**RE: Fair Chase Drive at South Firethorne Road "No Parking" request**

**Firethorne, Section 6  
Revised Control Map and  
Traffic Sign Layout**

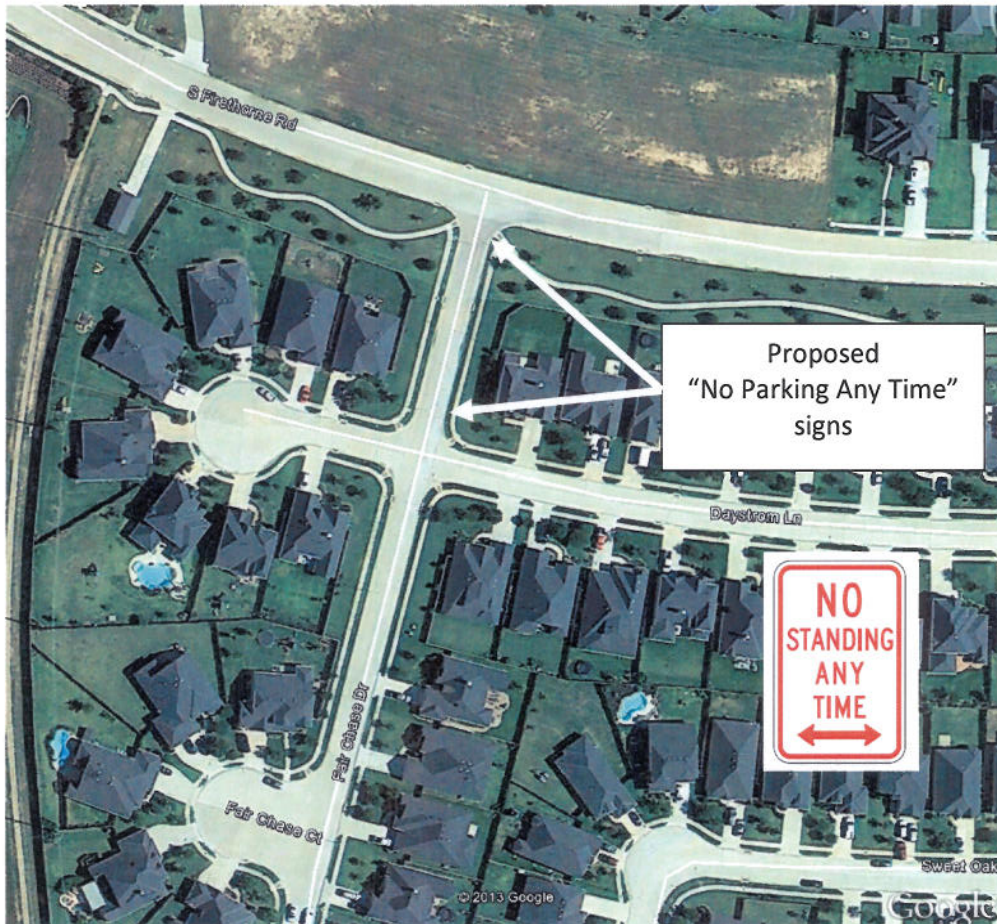
Due to vehicles being parked on both sides of the 27 foot wide roadway, only one lane is provided for vehicle travel. Several occasions were observed where a vehicle had to wait for oncoming traffic to clear before being able to proceed. This occasionally resulted in vehicles blocking South Firethorne Road. The photo below shows a sample view of the location (note the pick-up approaching South Firethorne Road).

Fort Bend County Engineering would recommend adding "No Parking Any Time" signs on the east side of Fair Chase Drive between South Firethorne Road and Daystrom Lane. This solution provides for two travel lanes on Fair Chase Drive at South Firethorne Road and reduces the number of parents that cross the street with their children.

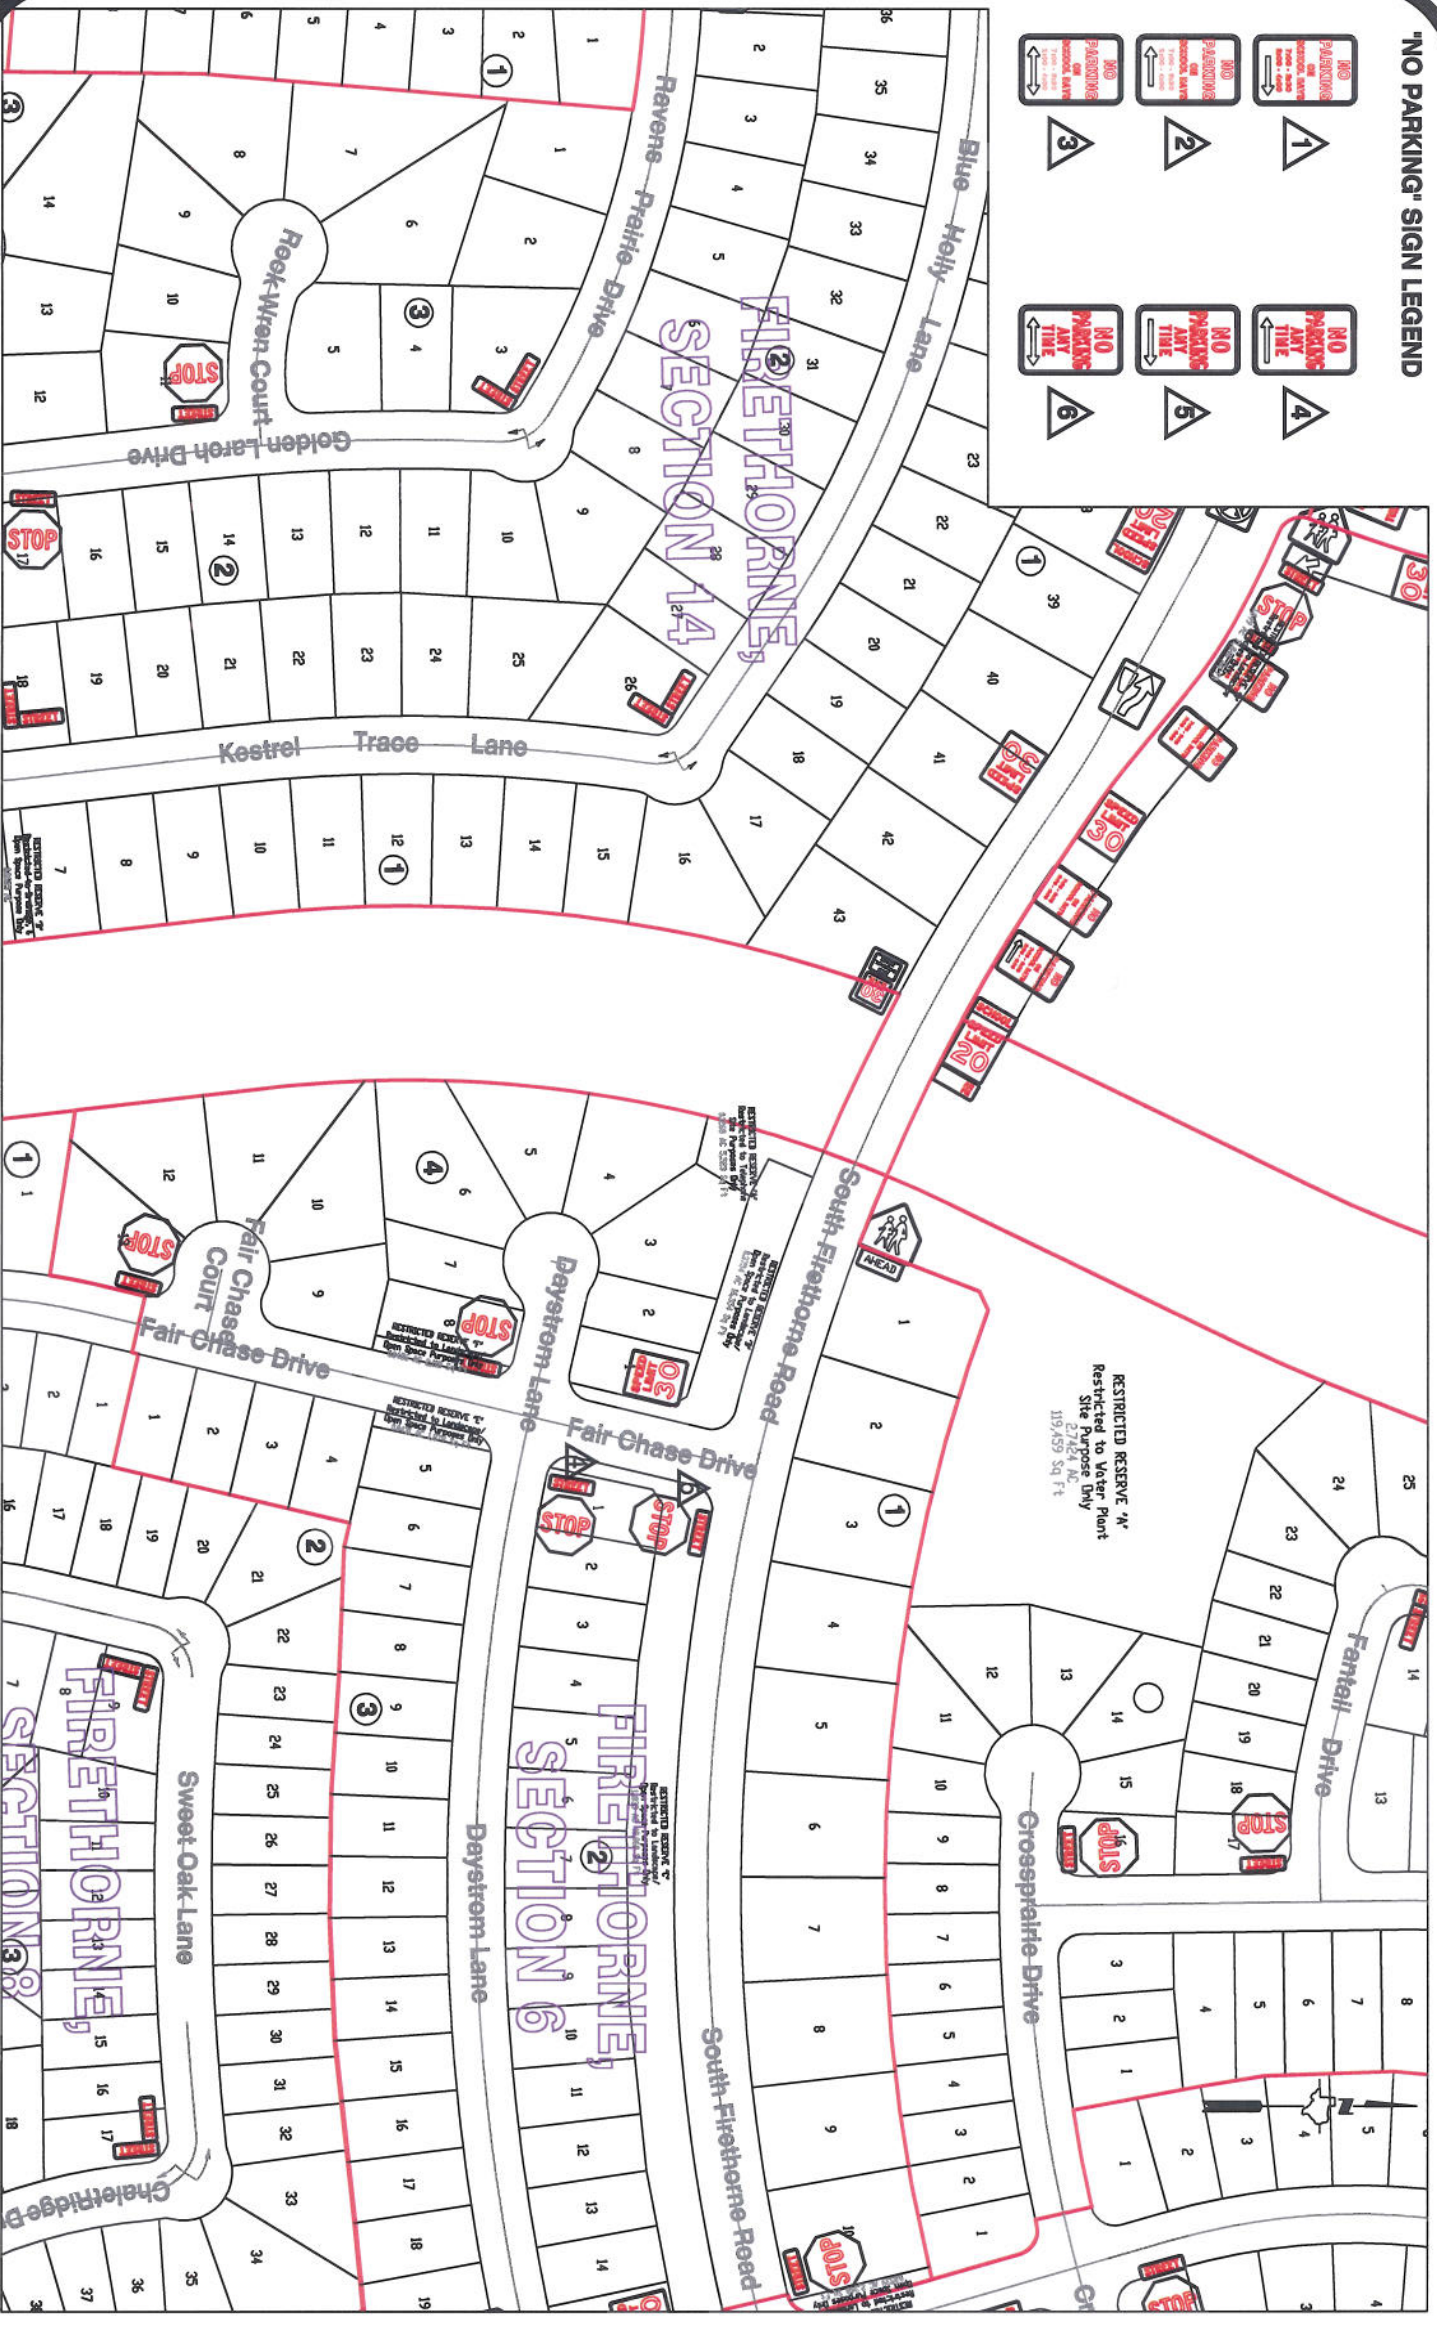
**Note:**  
The purpose of this traffic control plan is to revise traffic control for Firethorne, Section 6 with the addition of "No Parking" (R7-1) signs as indicated on the drawing.
